To bring the SOL_AMPV3 version 1.2 (production autumn 2017) close to version 1.7 that is the candidate for the production.

See the schematics SOL_AMPV3_1_7_sch.pdf that indicates all the changes.

Modification on the board

fig 2: Location and values of the resistors to be placed and measurement points

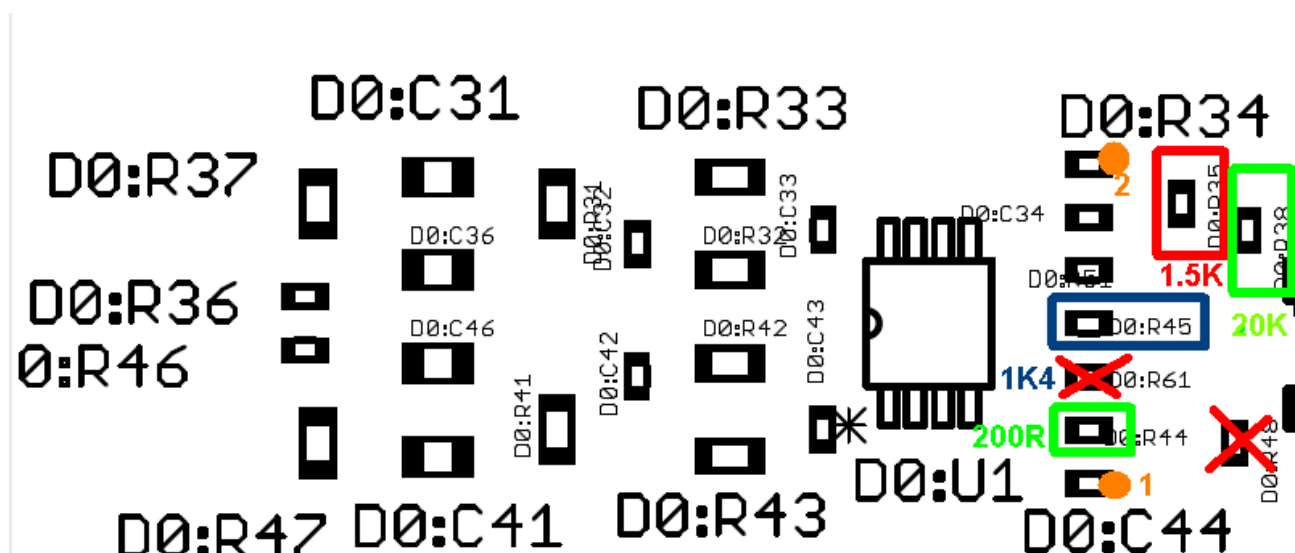
Remove Rx:R61 (wrongly placed)

All resistors 402 (~ 60mW)

Place 1K4 at Dx:R45

Place 1.5K at Dx:R35

place 20K at Dx:R38.

After the resistors are placed check the voltages¹ on the orange spots 1 and 2

Voltage spot 1 : min V max V

Voltage spot 2 : min V max V

One can check on the spot 3 (via) if the voltage is 0.9V. If this differs ($> 0.075V$) subtract the difference from the voltage limits given. (if $V_3 = 0.7$, then subtrack $0.9 - 0.7 = 0.2 V$ from the limits). V_3 should be within 0.7 and 1.1 V.

fig 3: locations of the resistors to be (re)placed and protection diodes mounted

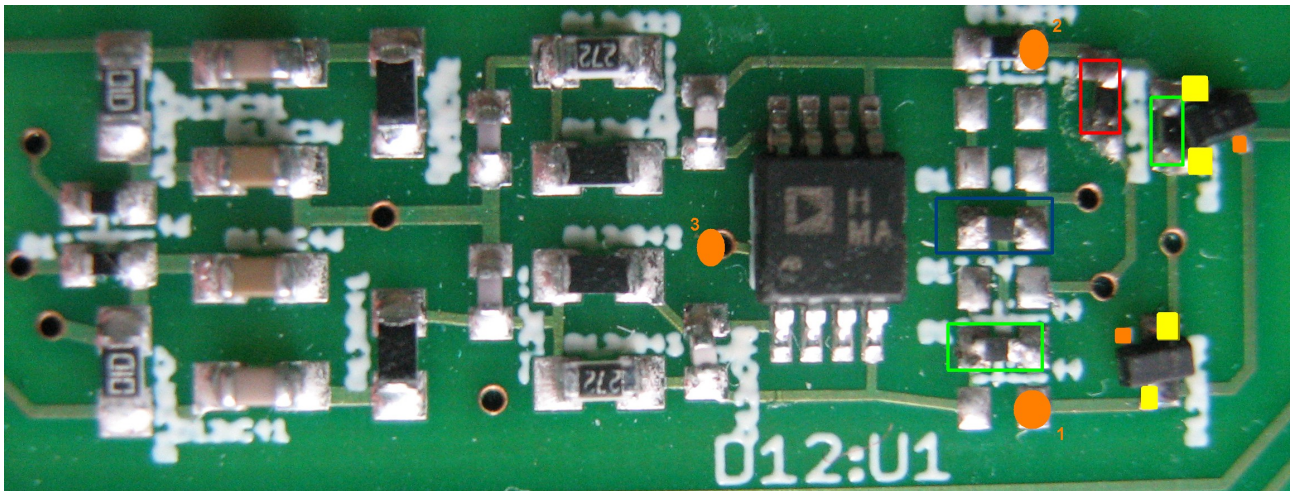
In fig 3 one can see how the protection diodes (Panasonic DB3S308F0L farnell : 2284977) have to be mounted.

Only the part of the diode that clamp negative voltage is connected. These pins are in fig 3 yellow indicated. The pin that is not connected is orange indicated. (In the final design this diode will clamp to the 1.8V positive going but no reliable mounting possibility has been found) .
